**MASTER PLAN UPDATE**

**SEHOME  
HILL  
ARBORETUM**

**City of Bellingham, Washington  
And  
Western Washington University**

### Sehome Hill Arboretum Master Plan Update

ENTRANCE  
PORTAL

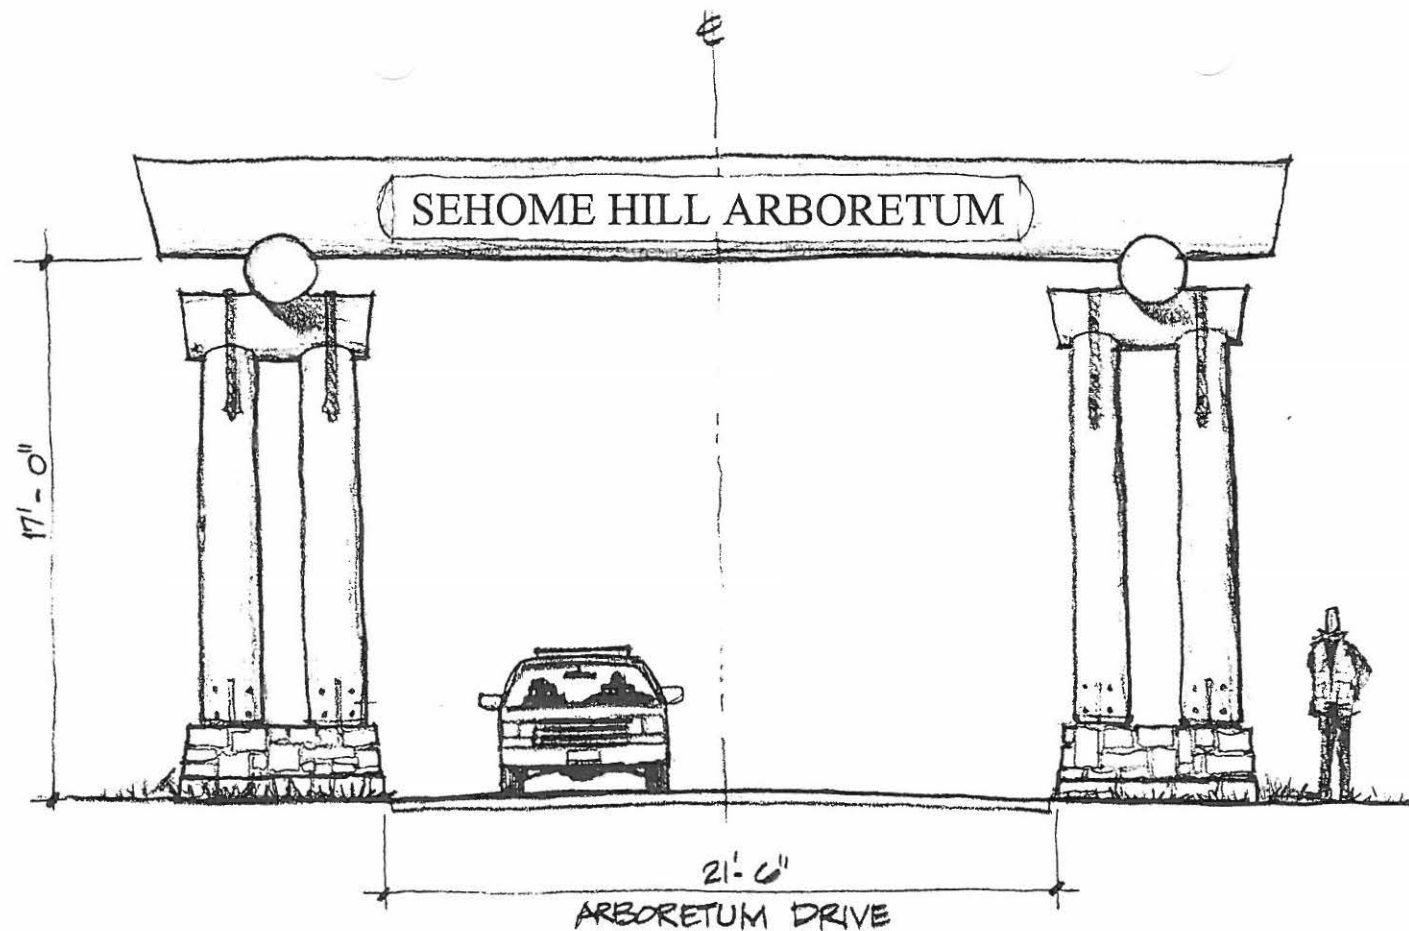
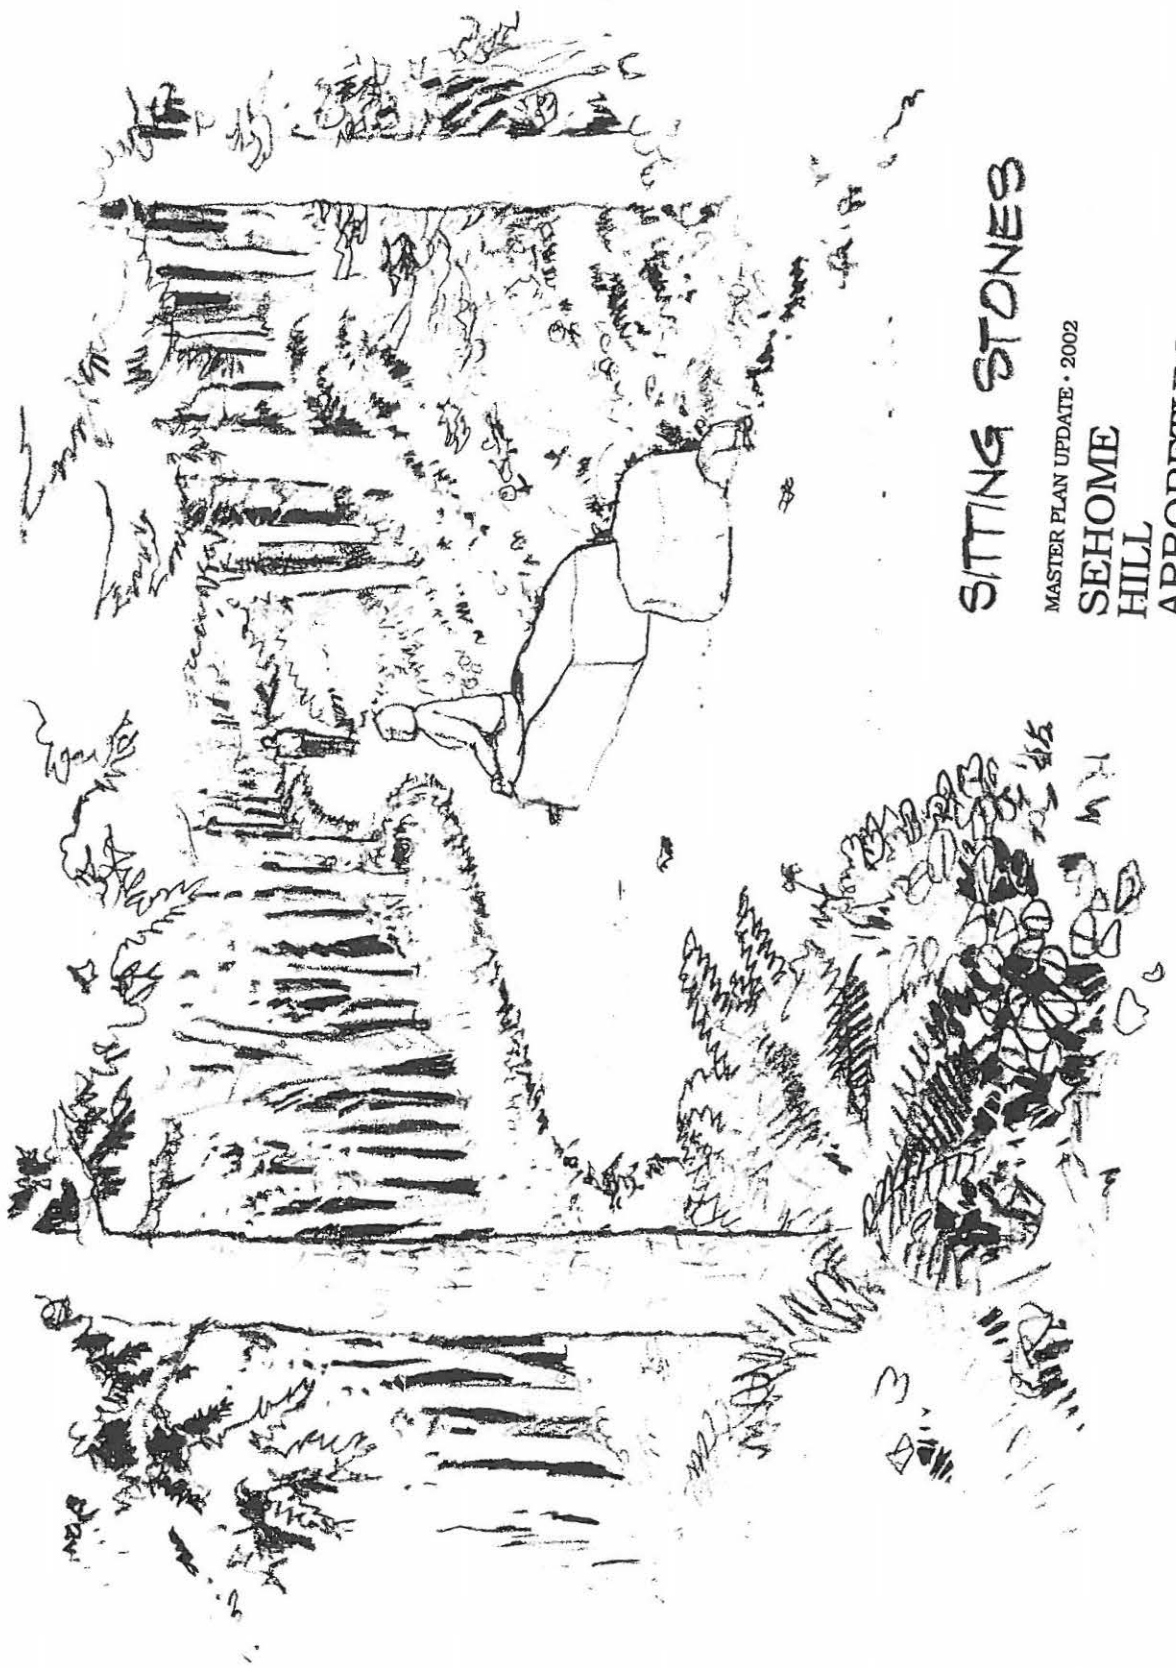
1. I like trees not logs.
2. Don't like a big entrance at all. Steve Carey
3. Rock benches seem like they might be neat. One has to worry about graffiti though. The entrance looks like the gate from Jurassic Park. Let the park speak for itself. **NO** ridiculous log contraption can say what it can.
4. I like this entrance concept.

The Board agreed with the majority of the open house comments that the entrance to the Arboretum should be simple and that a more formal portico was not needed. Both Board and public comments reflected the traffic and congestion problems with the 25th Street entrance, however, the development of a new access from Bill McDonald Park Way could be planned with WWU in future years.

# SITTING STONES

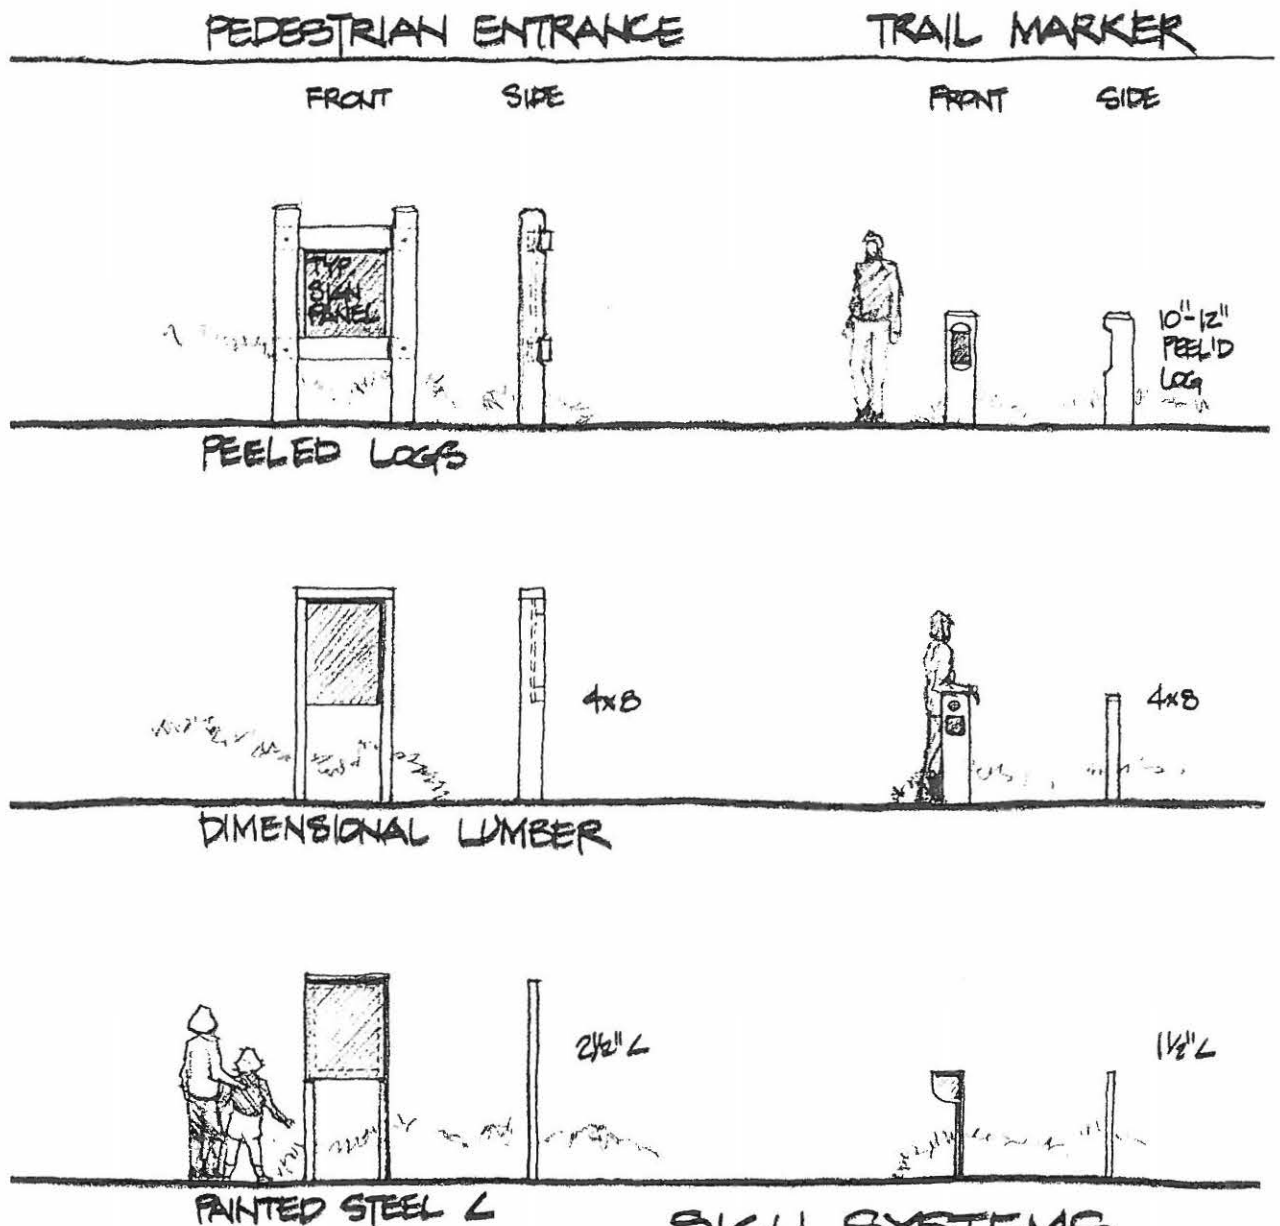
1. I like the sitting stones and the Arboretum drive entrance.
2. NO "memorial" benches please!
3. Do not enlarge any trails.
4. Only sitting stones where it's already cleared if needed.
